### Shake Shack (Chesterfield) - Commissioning

**Name :** (FIV) MECHANICAL RR Exhaust - Above Ceiling **Status :** NotSubmitted  
**Assigned Organization :** MULTIPLE **Asset :**  
**Requesting Organization :** National TAB

##### RESTROOM FAN ABOVE CEILING DETAIL

**Gravitydamper.jpeg**

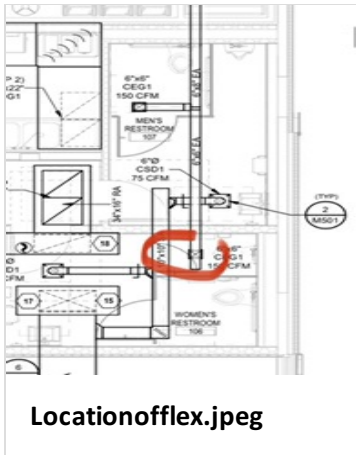
Gravity damper properly installed, sealed to curb and able to operate by hand

Flexkink.jpeg

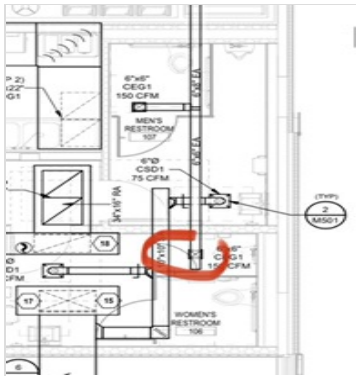
Flexible duct is supported and routed to prevent kinks

No
